TRANSPORT IMPACT ASSESSMENT

PROPOSED MULTIPLE DWELLINGS

203 ESPLANADE, REDLAND BAY

(RESPONSE TO INFORMATION REQUEST DATED 2 JULY 2025)

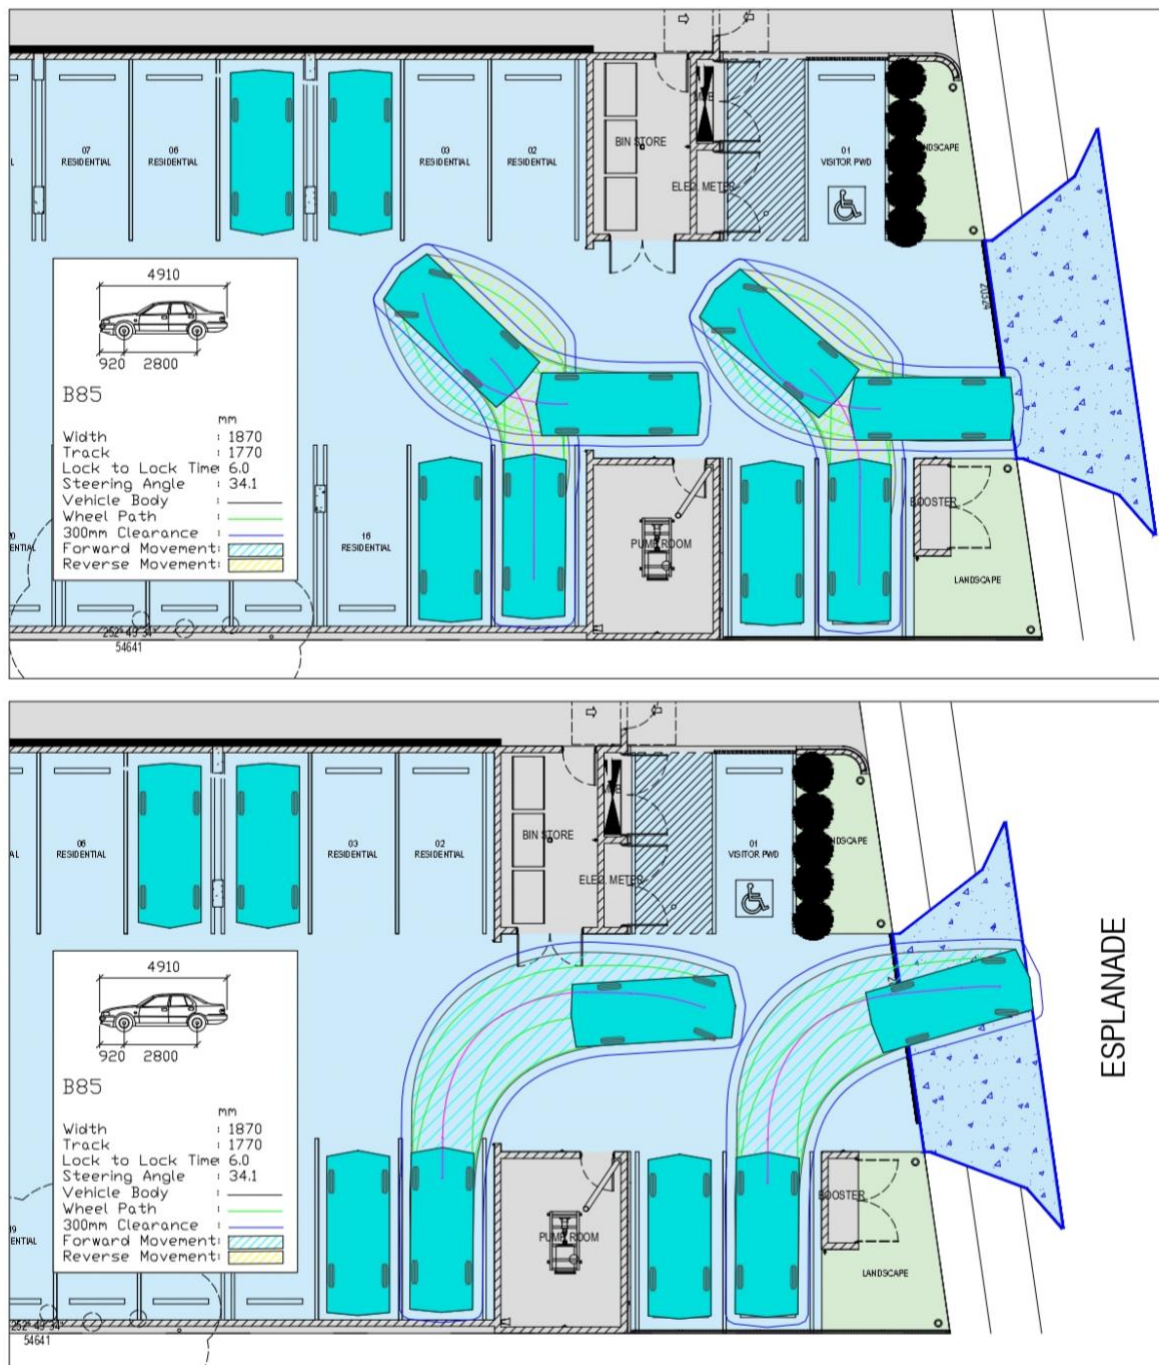
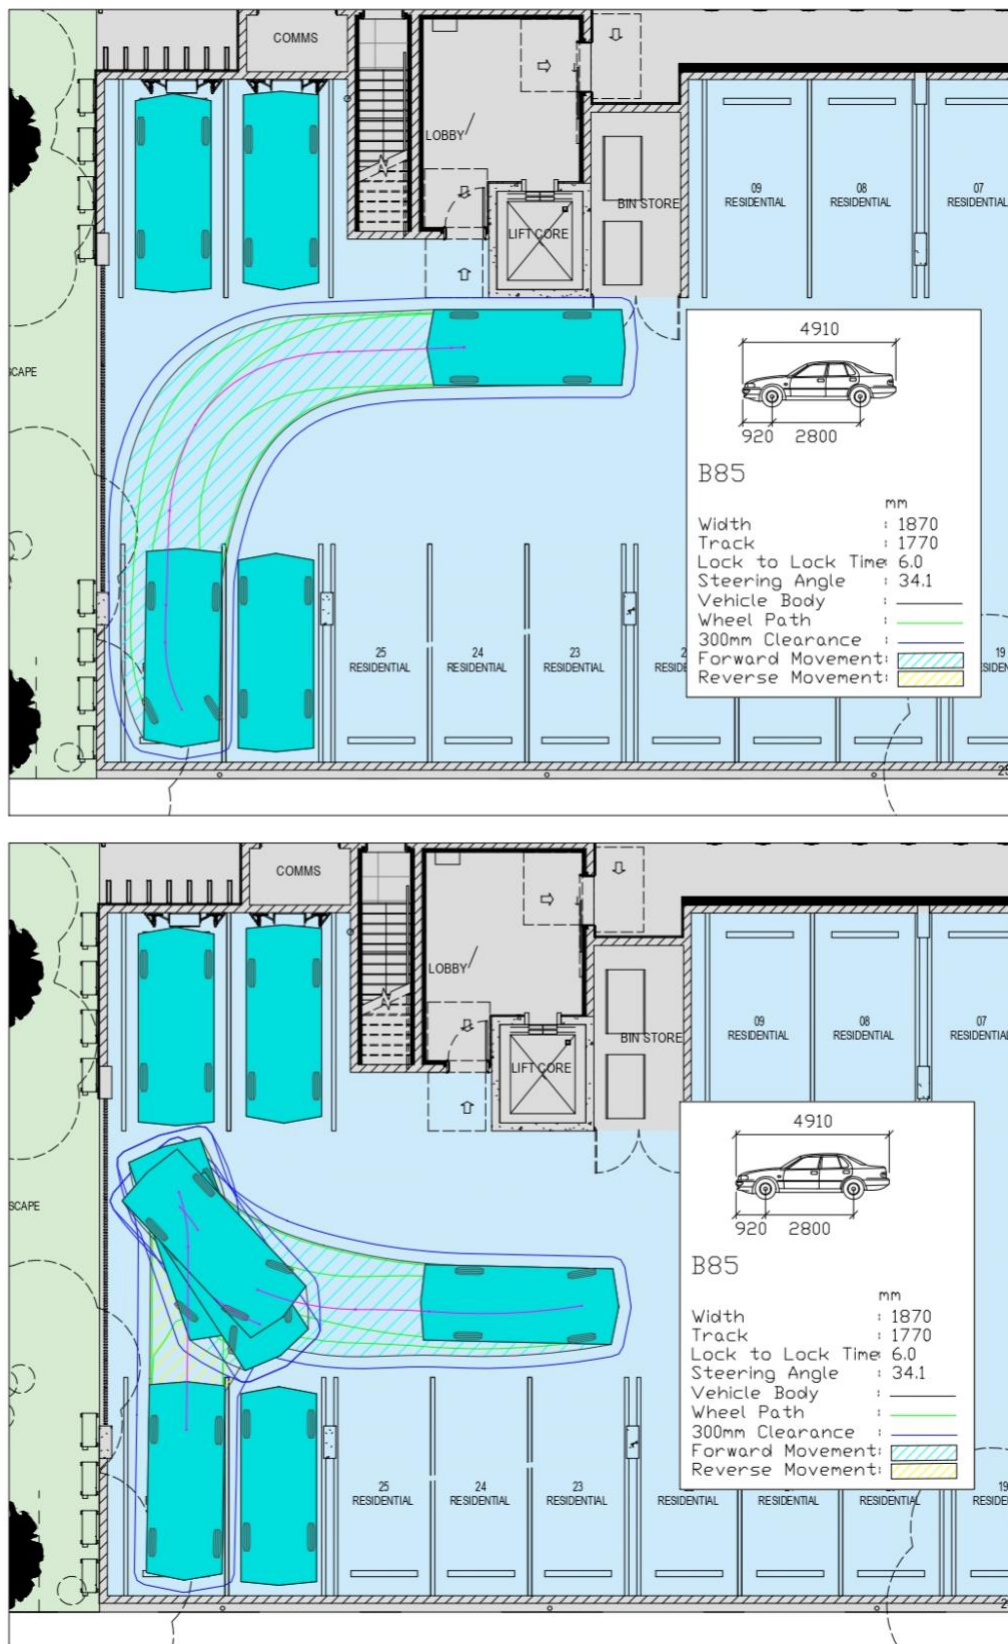
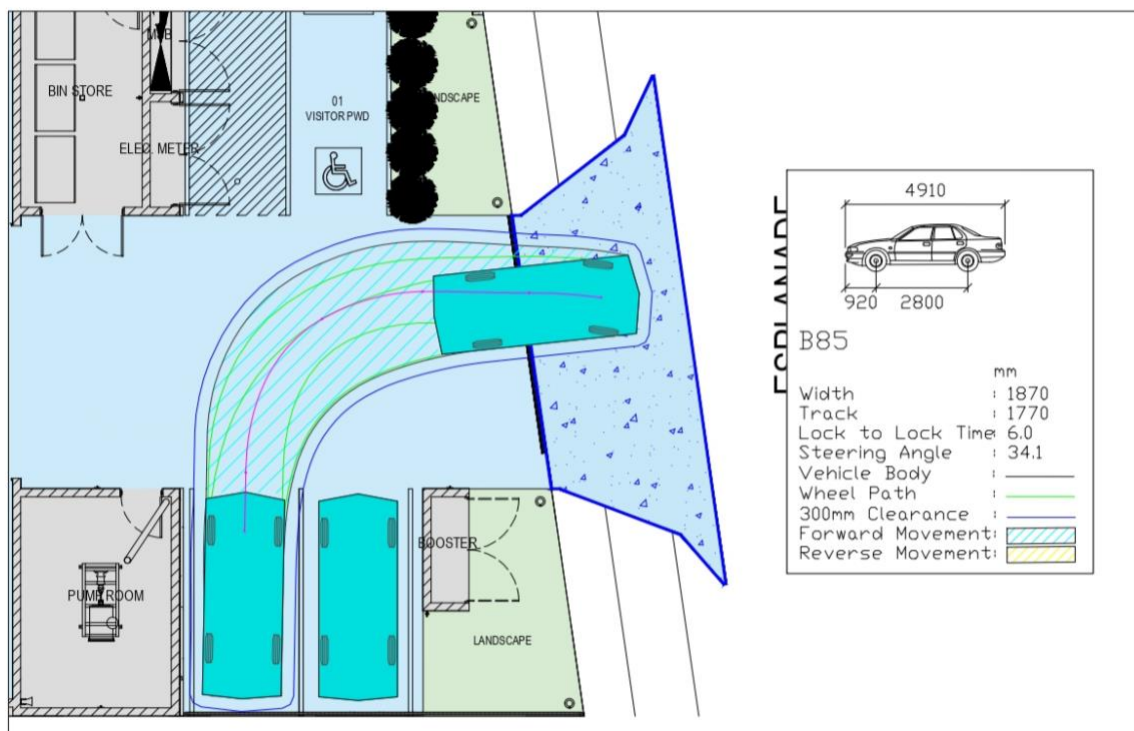
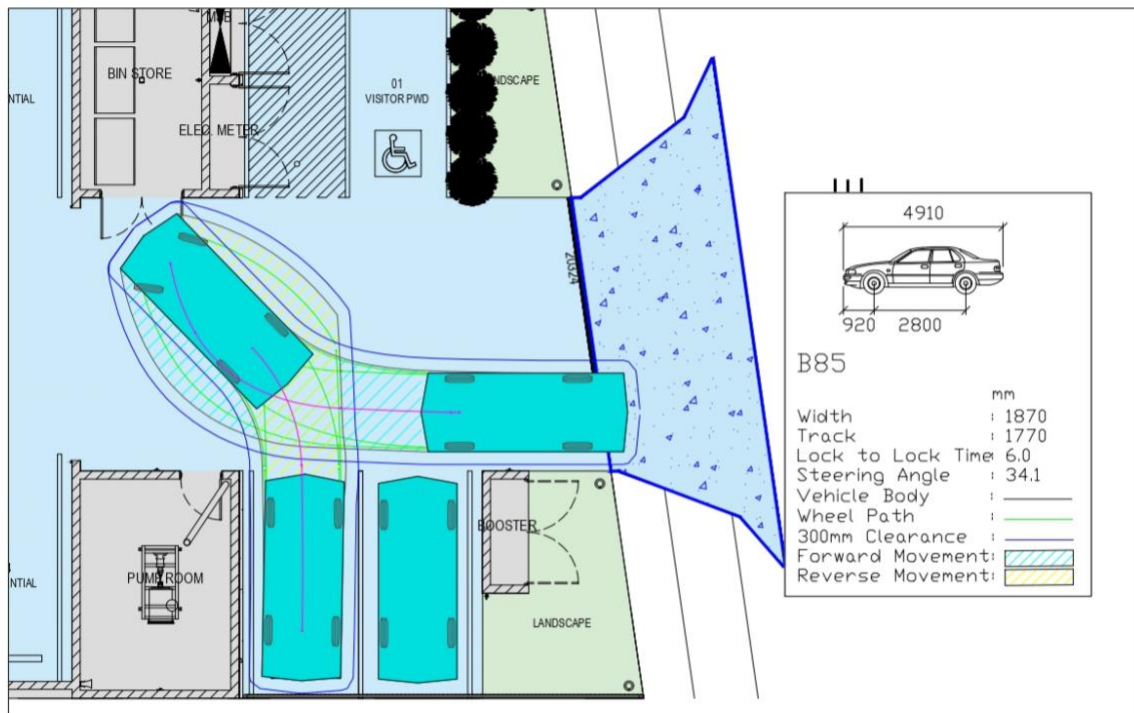
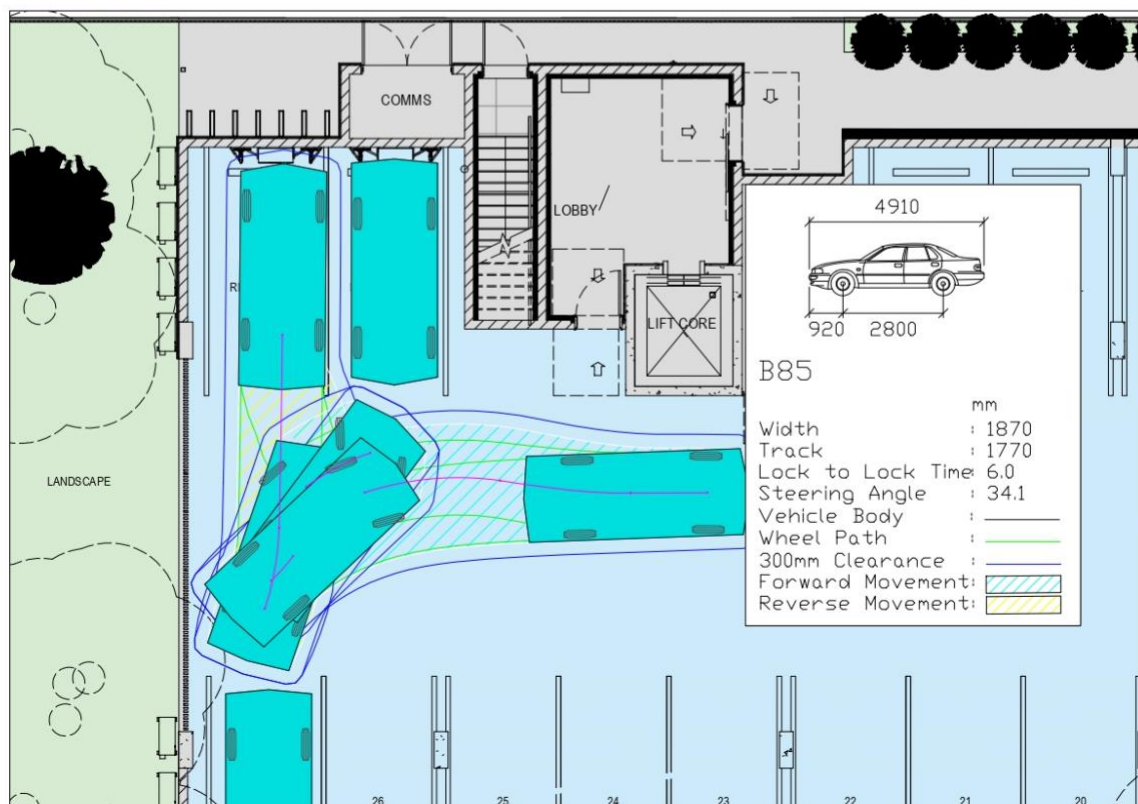
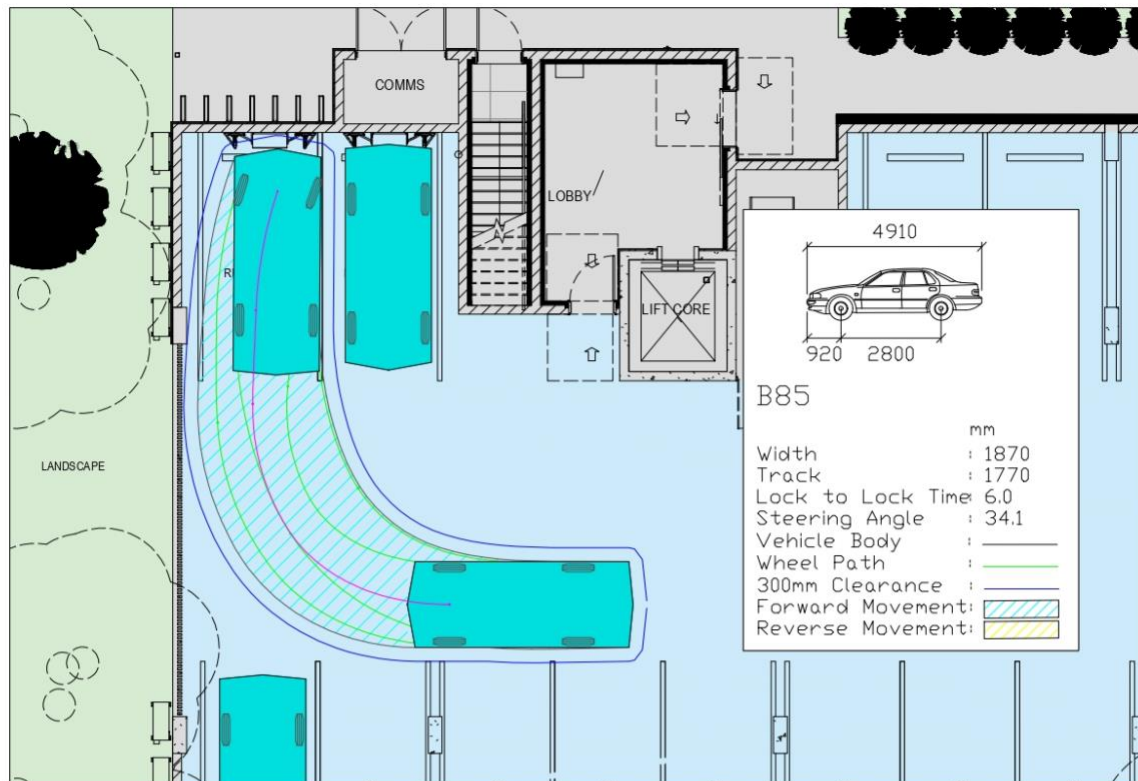
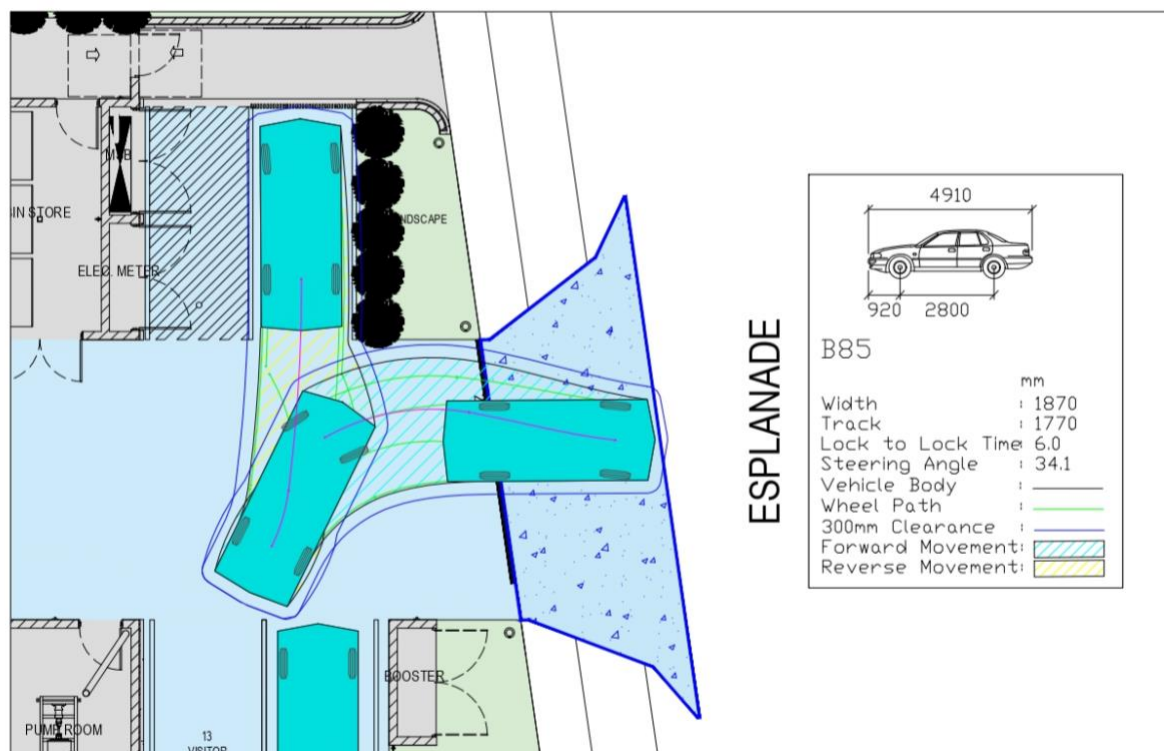
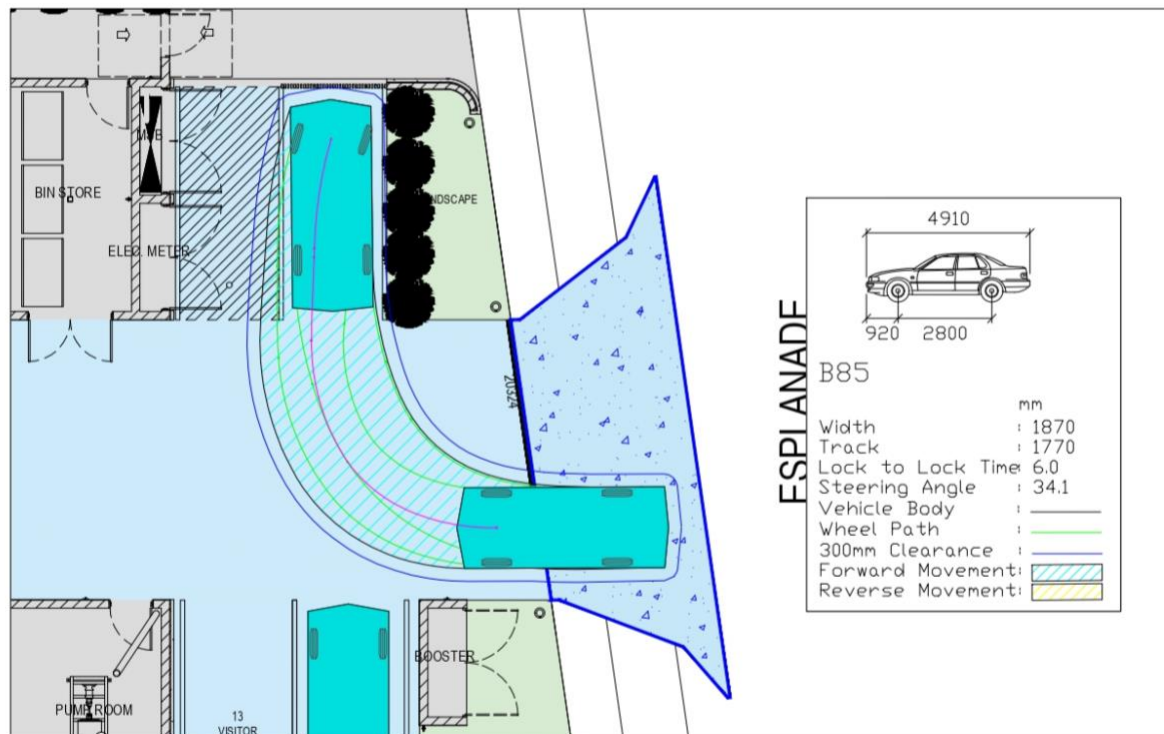
6. The swept paths shown in the Traffic Impact Assessment (TIA) by rytenskild Traffic Engineering (24291 V1, dated 24 January 2025) are inconsistent with the architectural drawing Ground Level by think tank architects (36-24 TP101 Rev. 6, dated 25 March 2025). The following issues arise as a result of the inconsistencies and will need to be revised:

- Swept paths shown in the TIA for access to all parking spaces.
- Access by a design vehicle (car) has not been demonstrated for parking space no. 11 (western end) due to the blind aisle now not extending past the parking space sufficiently to enable turning manoeuvres that would not be considered excessive.
- The driveway length between the property boundary and the car park gate, and positions of the visitor spaces, result in the queuing area not meeting the standards required for queue length and vehicle manoeuvring.

Provide a revised design that accommodates access to all resident parking spaces by the design vehicle, queued vehicles on-site, and enables visitor space parking manoeuvres and waste collection vehicle manoeuvres to be conducted on-site while avoiding conflict with vehicles and pedestrian activities. In doing so, demonstrate compliance with performance outcomes PO8, PO9, PO18, and PO20 of the transport, servicing, access and parking code.

The TIA and associated swept path analysis have been updated to align with the latest architectural plans. Access arrangements have been reviewed, and the aisle adjacent to space 11 has been widened to 6.5 metres, allowing improved manoeuvring for vehicles using the space.

Sufficient setback is provided from the property boundary to enable at least two vehicles to queue clear of the frontage, which is considered satisfactory given the scale of the development.

It is acknowledged that visitor parking has been positioned within the queuing area of the site access. This arrangement is considered acceptable given the development is expected to generate a low level of visitor demand and a low turnover from the provision of only three (3) visitor spaces. On the rare occasion that a visitor is departing as a vehicle is entering, there is adequate space for a vehicle to wait momentarily within the driveway clear of traffic along the Esplanade. The inclusion of visitor parking within access queuing areas is common for developments of this scale and nature and is not expected to adversely impact the operation of the site.
